MONTGOMERY COUNTY HISTORIC PRESERVATION COMMISSION
STAFF REPORT

Address:	10221 Montgomery Avenue, Kensington	Meeting Date:	6/14/2023
Resource:	Contributing (Primary One) Resource Kensington Historic District	Report Date:	6/07/2023
Applicant:	Bruce Caswell and Lauren Deichman (Mike Roberson/McFarland Woods, Agent)	Public Notice:	5/31/2023
Review:	HAWP	Tax Credit:	N/A
Case Number:	1029631	Staff:	Rebecca Ballo
PROPOSAL:	After the fact demolition of the garage and construction of a new garage

STAFF RECOMMENDATION

Sheet No.
A101
 COPYRIGHT, 2020 GTM ARCHITECTS, INC.

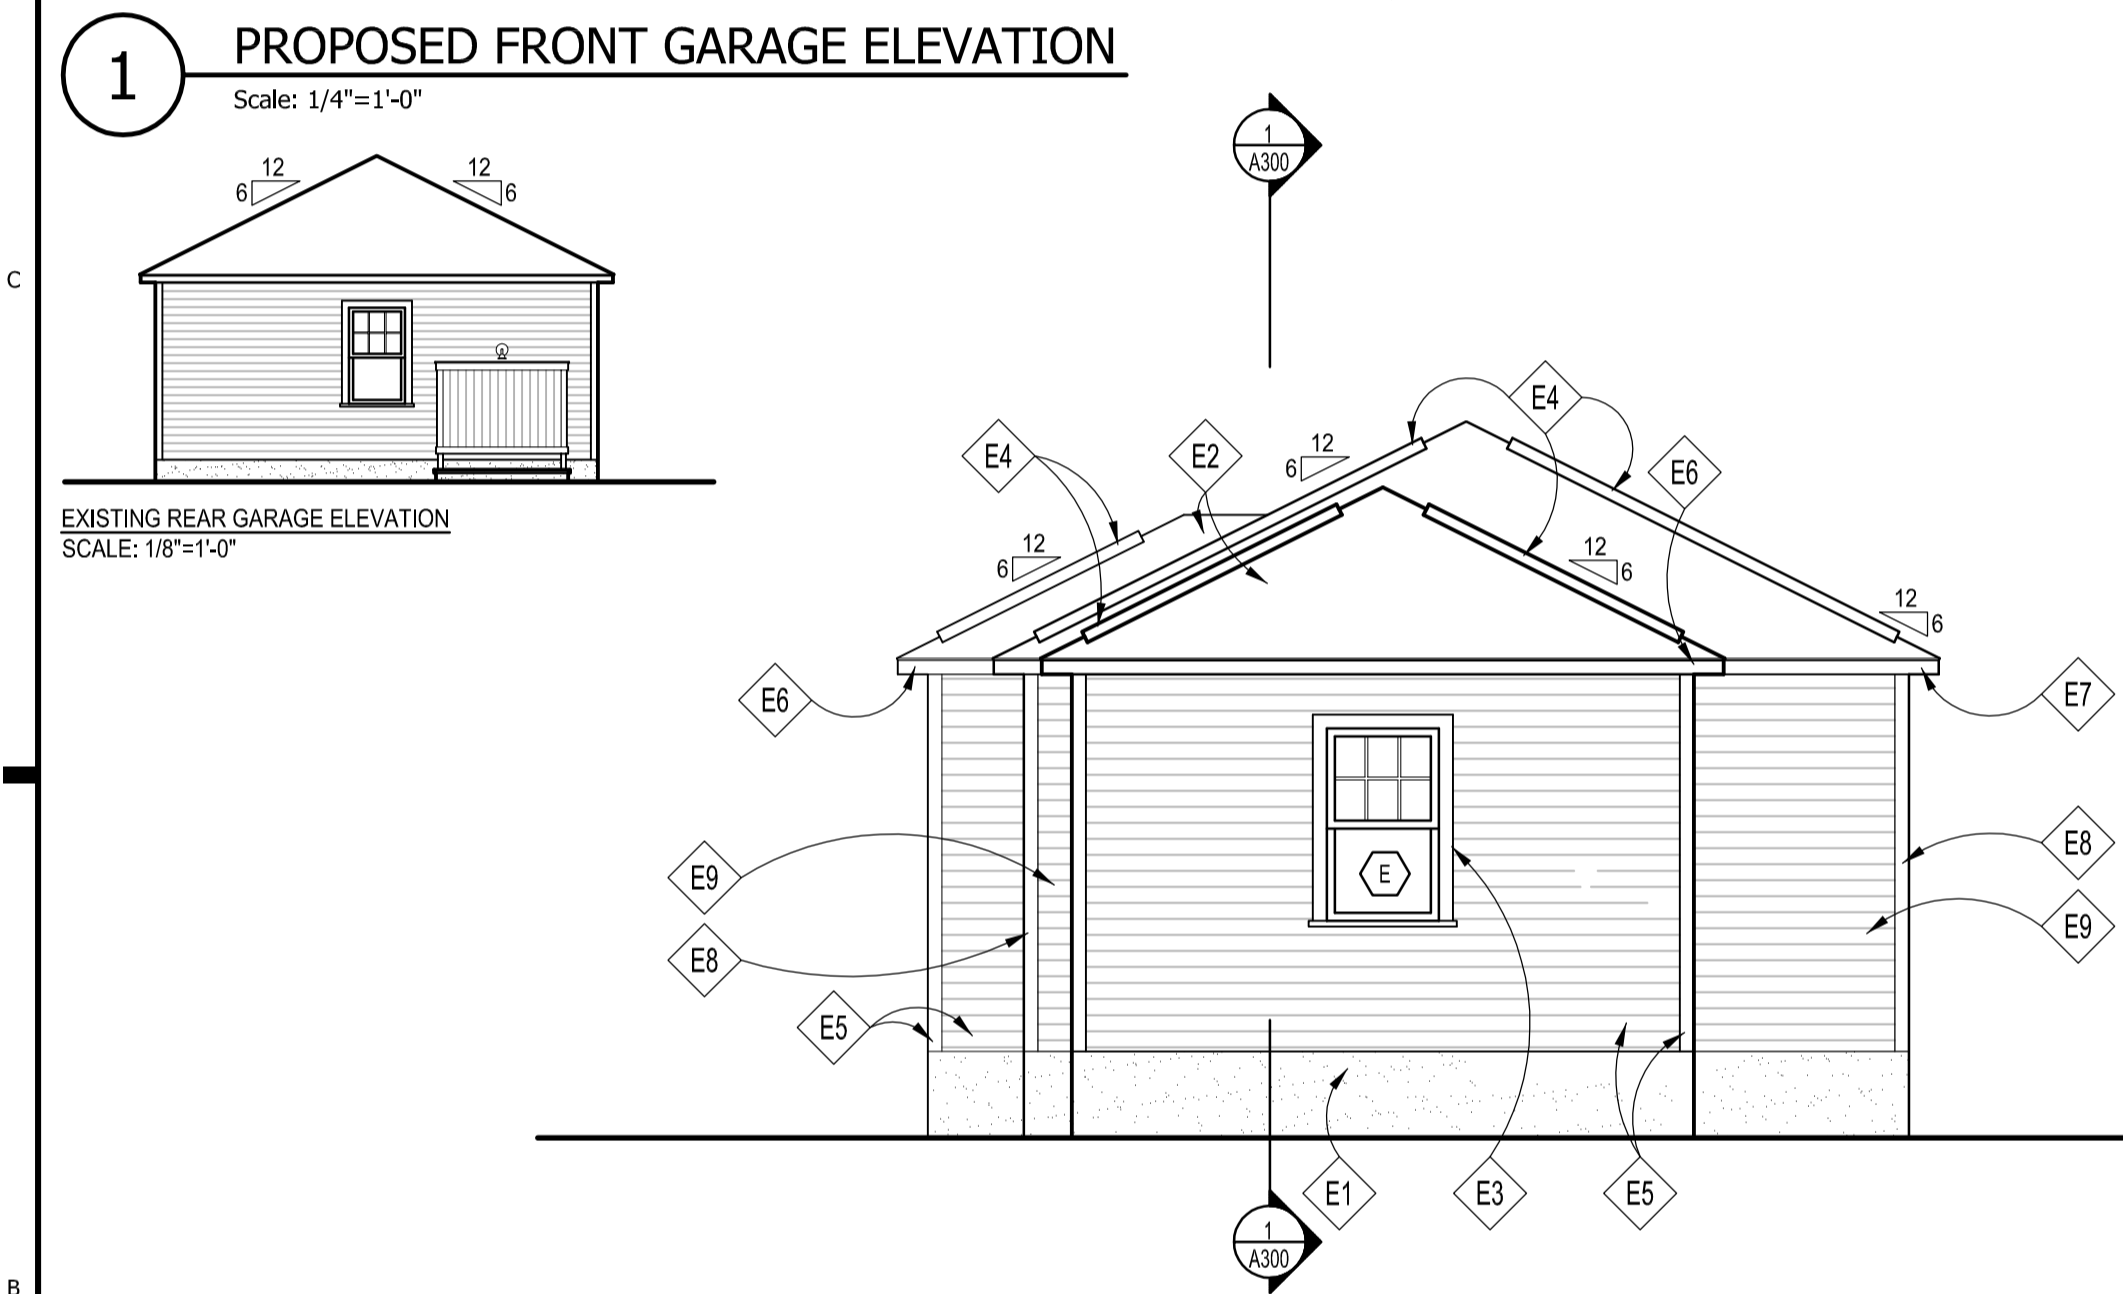
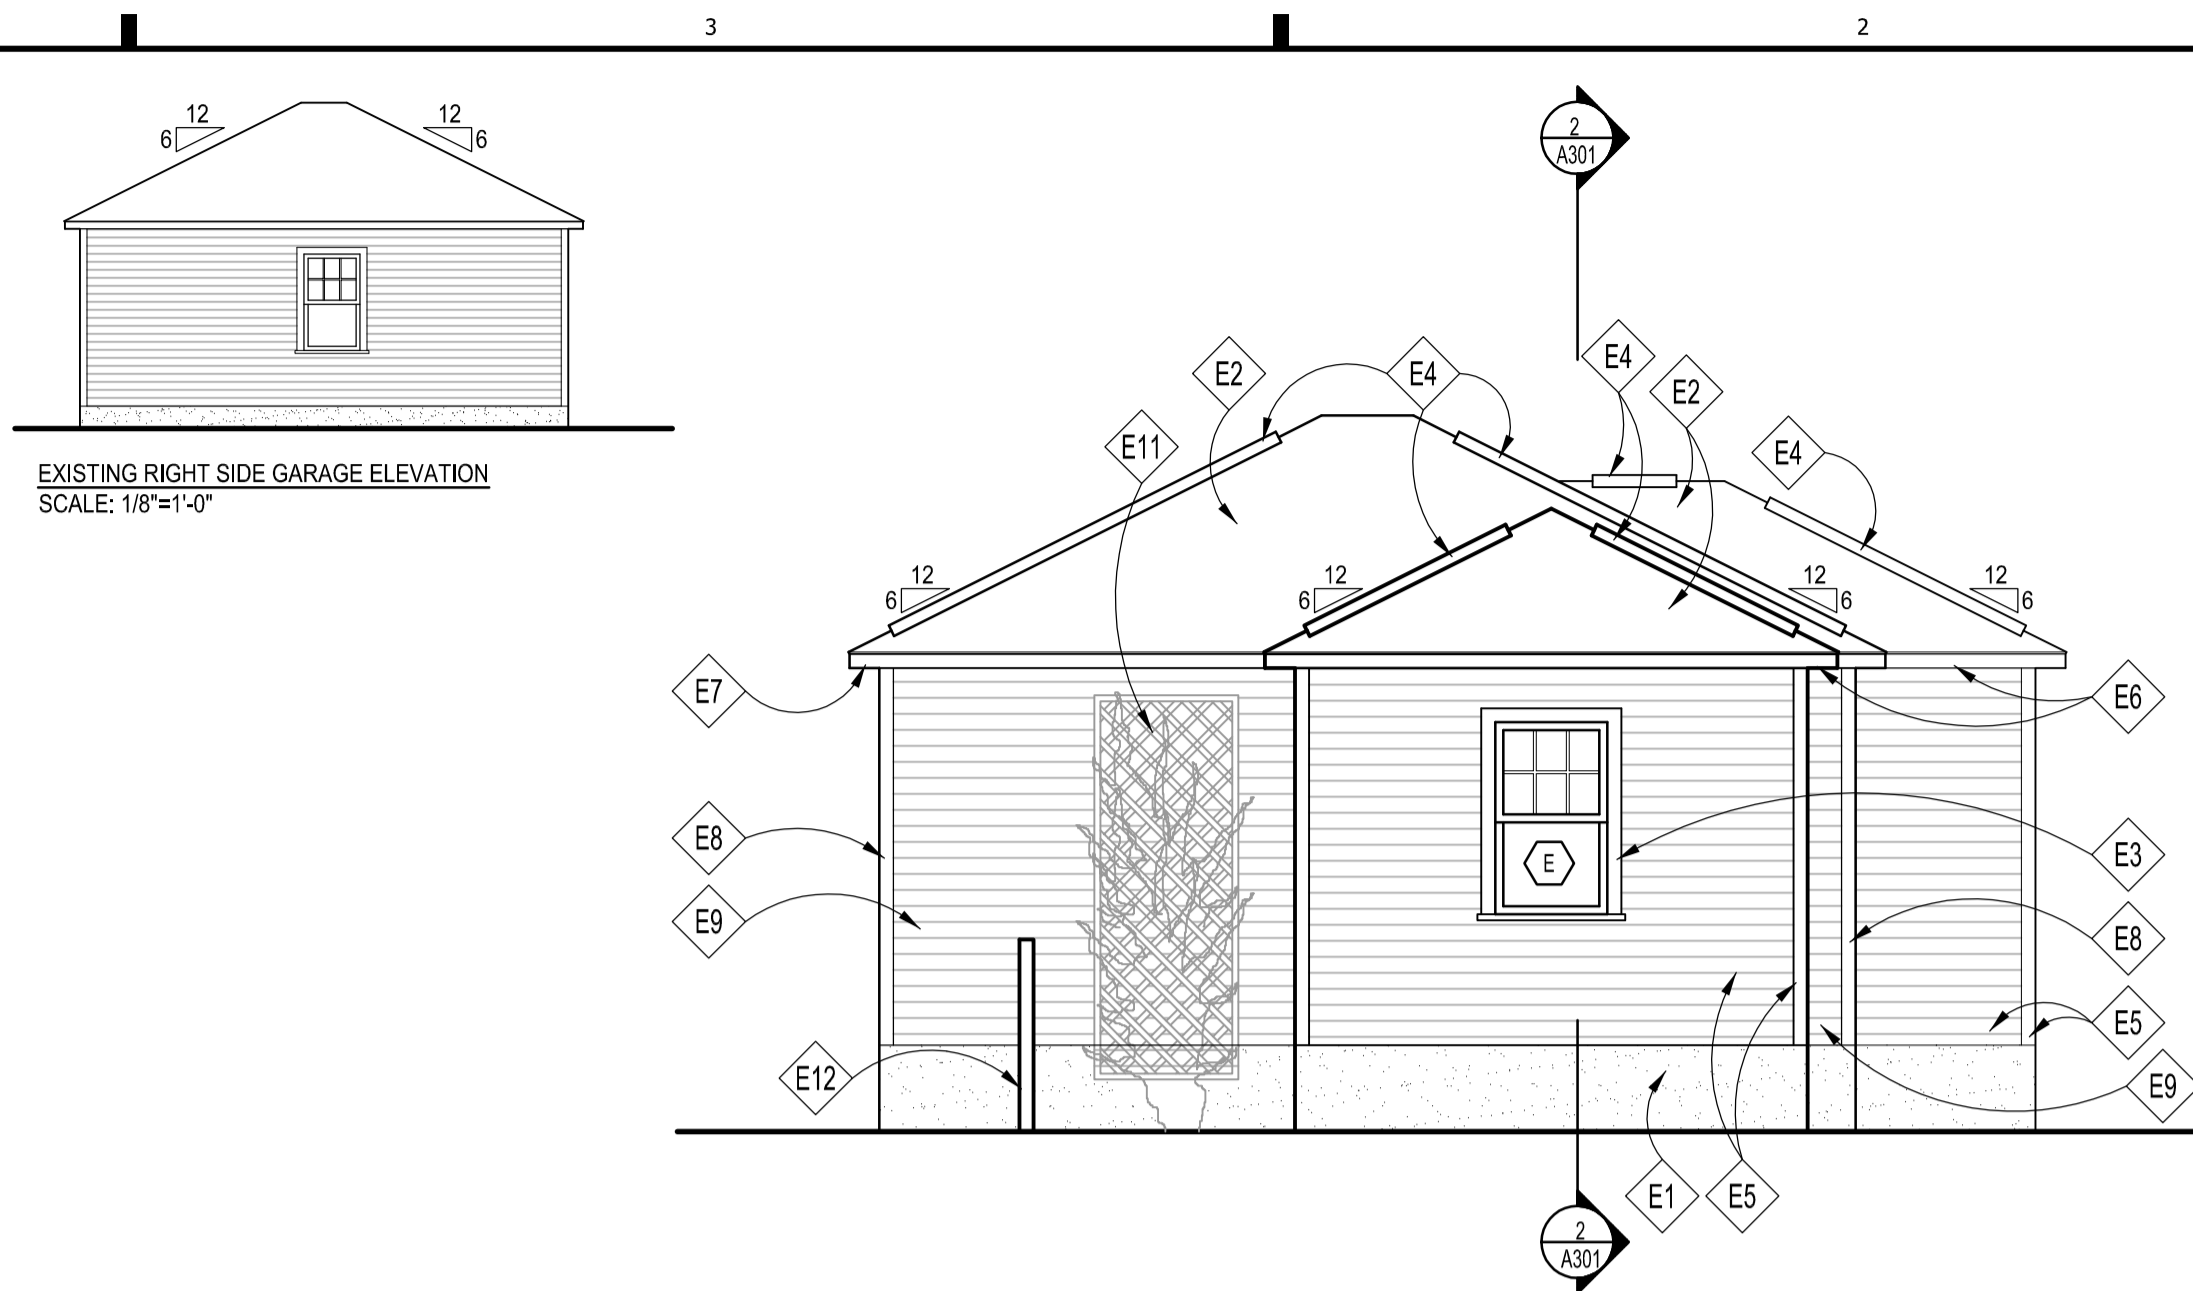
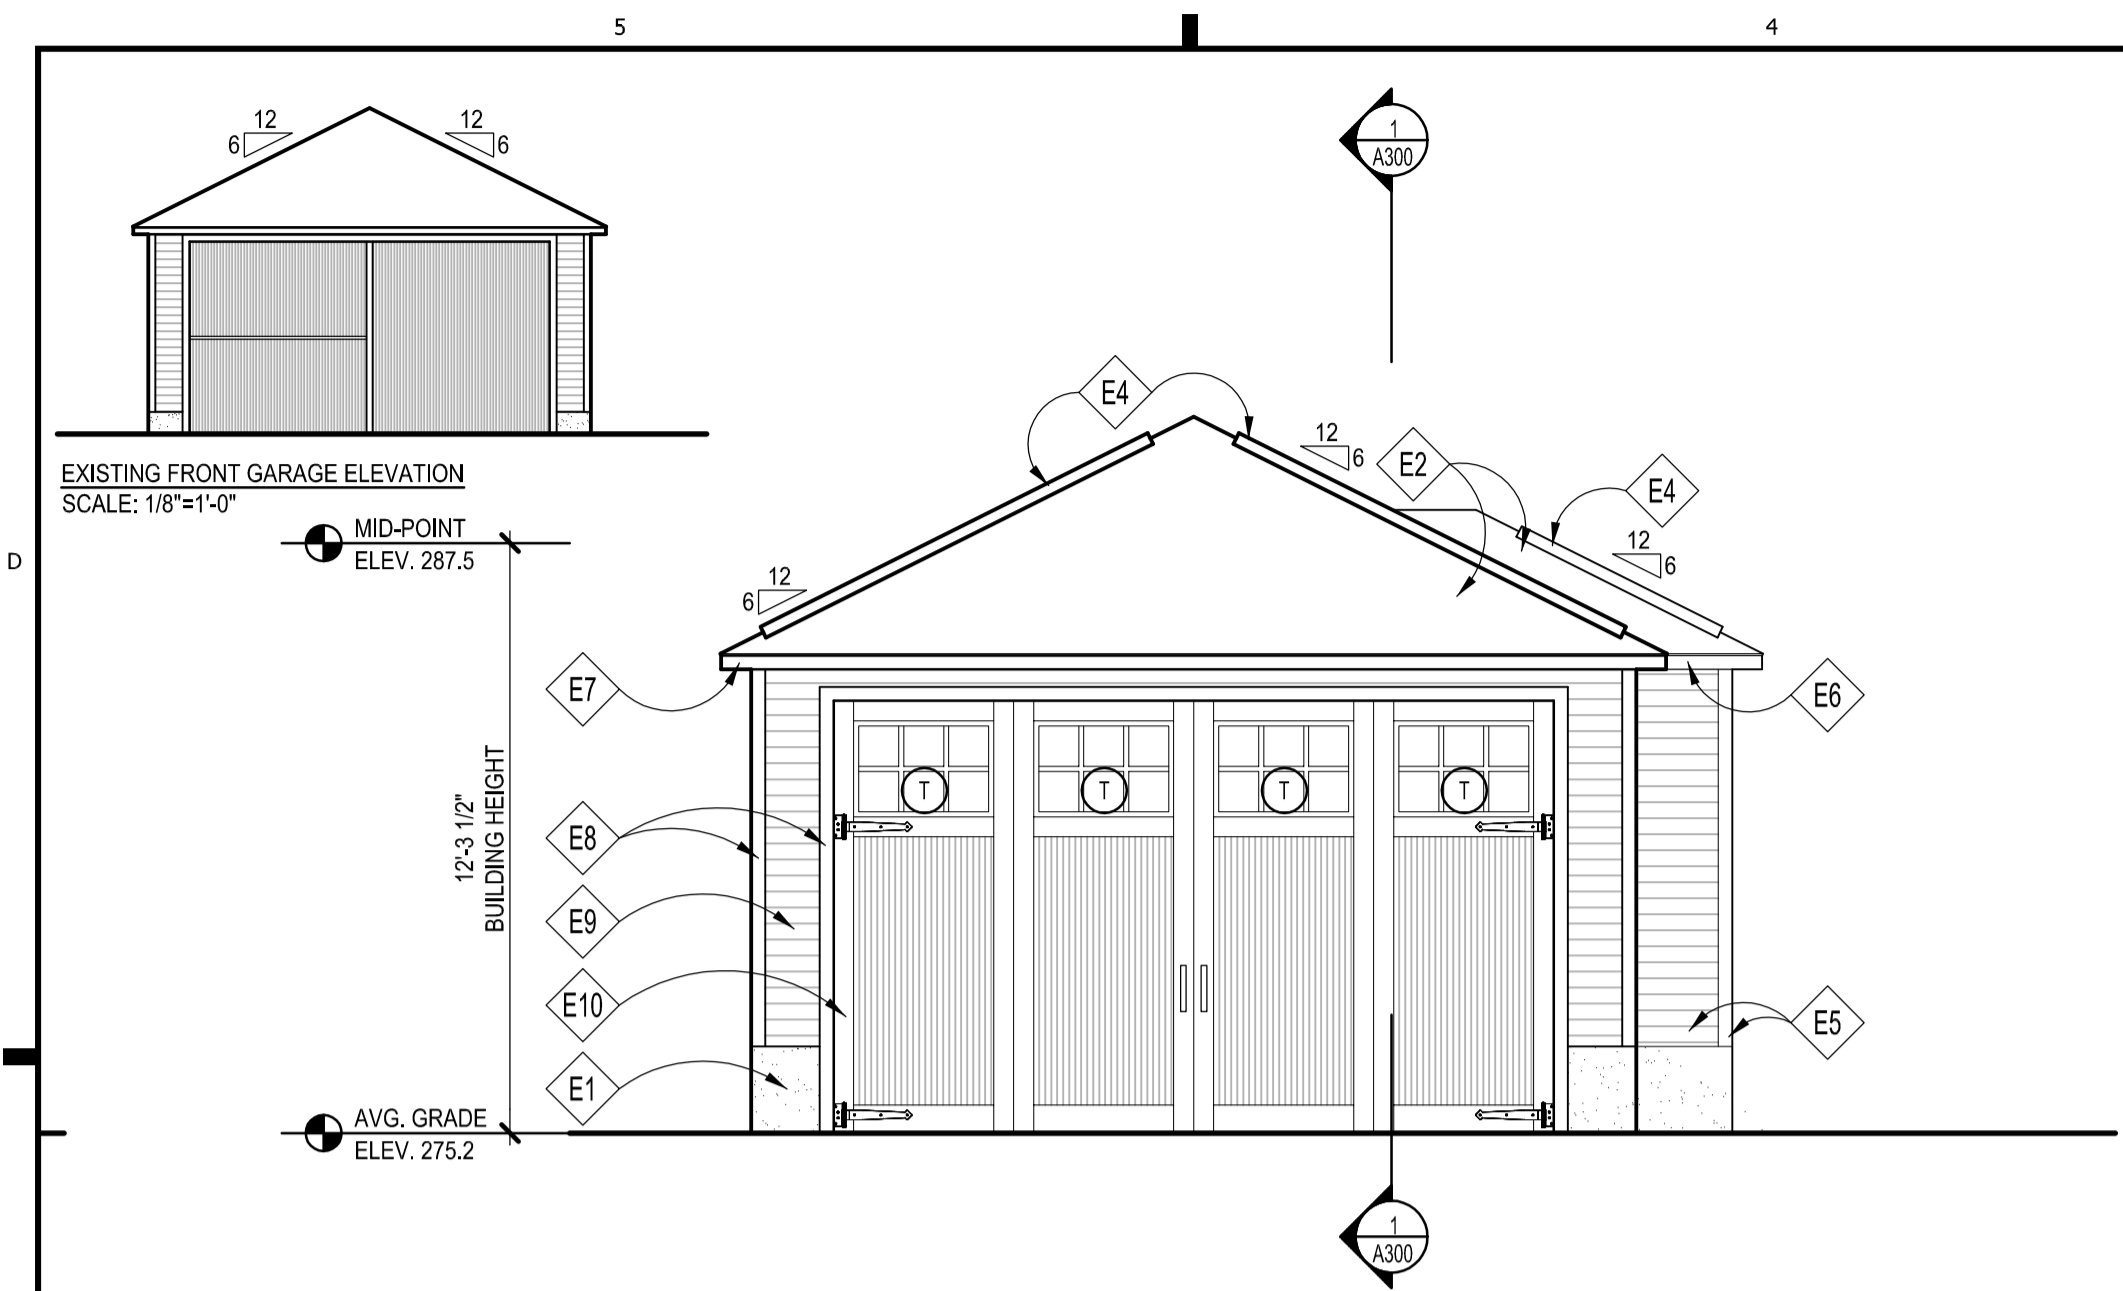
The proposed building will also have an asphalt-clad hipped roof with a 12/6 pitch to match that of the original garage. The proposed garage will rest on a parged CMU foundation, and be clad in painted wood siding to match the original. All material notes on Sheet A200 of the submittal note that all materials will be wood. Notes on Sheet A200, A300 and A301 note that windows and other historic building materials will be reused.

As-built conditions in the field (see attached photographs), however, show that the historic windows were not reused and the single windows in the garage now all have a 1/1 configuration as opposed to the proposed 6/1 from the initial submittal. The garage doors appear to be built as proposed. Other inconsistencies are in the width of the siding—which appears to have a 5"-6" reveal as opposed to the narrower 3"-4" reveal from the original that was proposed to be maintained. The pool equipment that was proposed to be located inside the structure remains on the rear; however it is now exposed and unscreened, whereas the equipment was screened previously. The fascia board beneath the soffit is also more substantial than what previously existed and appears to be several inches taller. In essence, the fine-grained and charming details from the original garage that were once proposed to be retained and replicated with (and which are shown in the submitted drawings), have been removed from the garage that was actually built.

- 2) The single hung windows shall be 6/1 to match those from the demolished garage. The windows may be wood or aluminum clad wood, with simulated-divided-lite spacers. Final details of the windows shall be shown on the revised drawings;

- 3) The siding shall be wood, lap siding, with a reveal no greater than 3”-4”;
- 4) The fascia throughout shall be reduced to have a reveal no greater than 6”;
